1 ELECTRICAL PLAN - FIRST FLOOR
SCALE 1/8" = 1'-0"

MAINE PORTLAND & RIVERSIDE
160 RIVERSIDE STREET
PORTLAND, ME 04103
DATE: 17-21
BY: JDH
PROJECT: BUILDING PERMIT SET
DATE: JAN. 09, 2019

ELECTRICAL FIRST FLOOR PLAN

Reviewed for Code Compliance
Permitting and Inspections Department
Approved with Conditions
02/14/2020

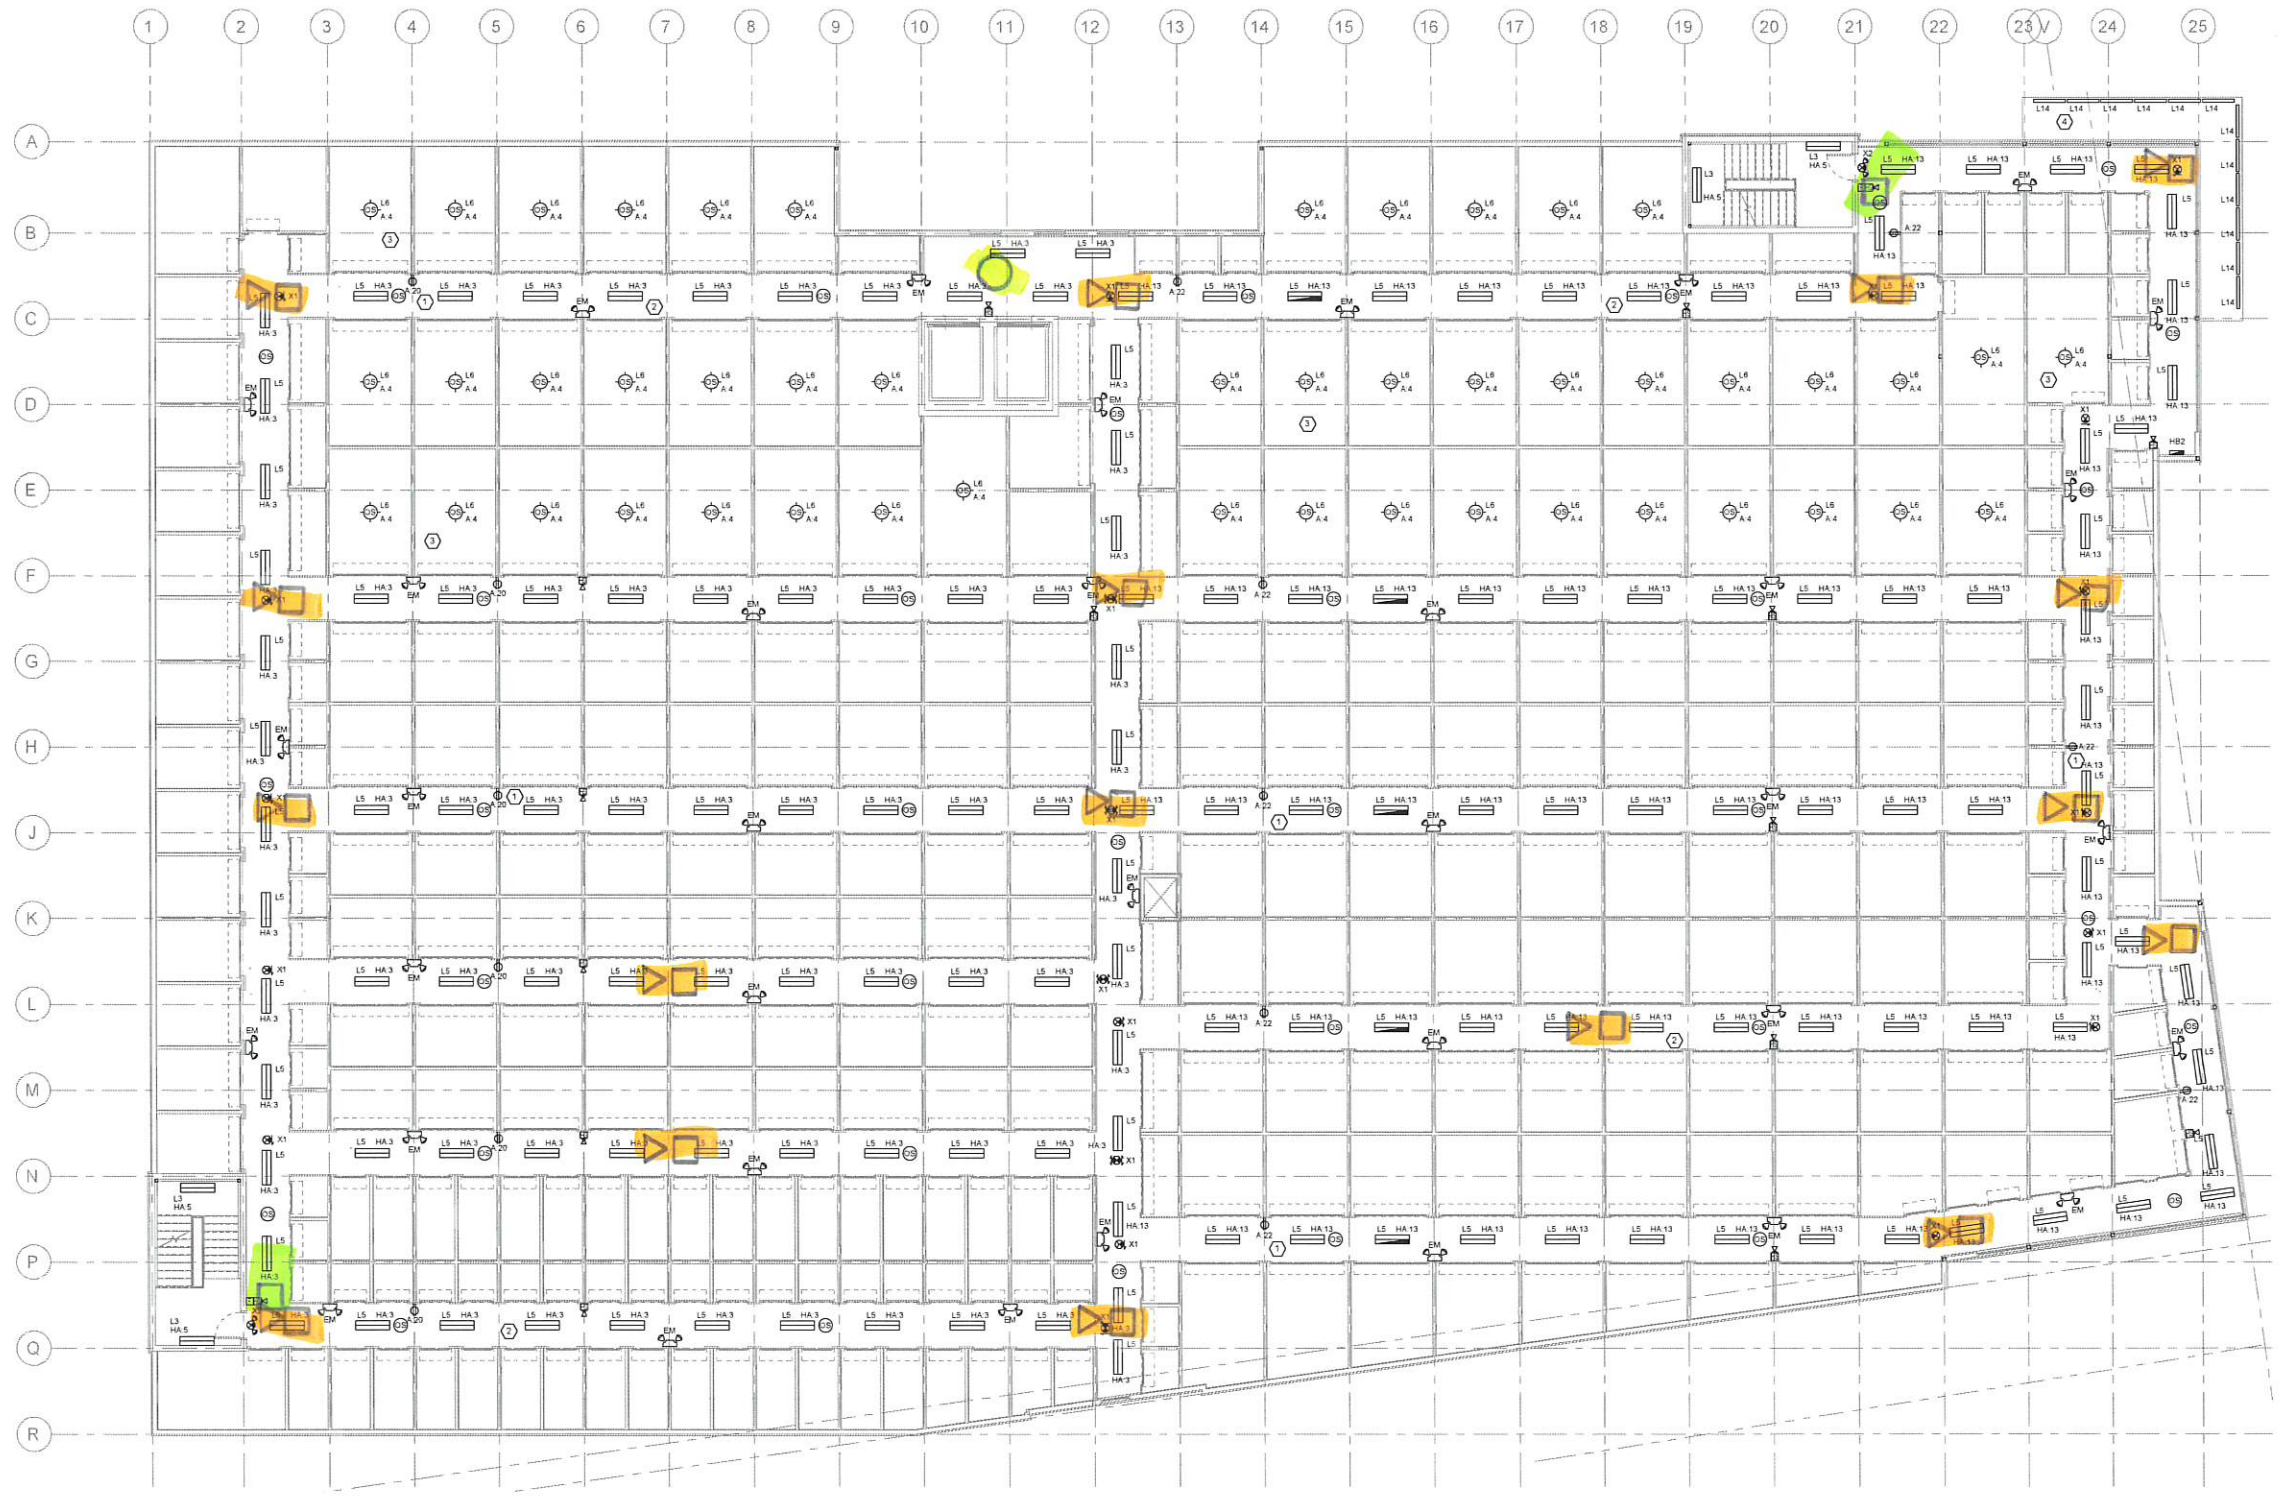
FACP
Knox Box
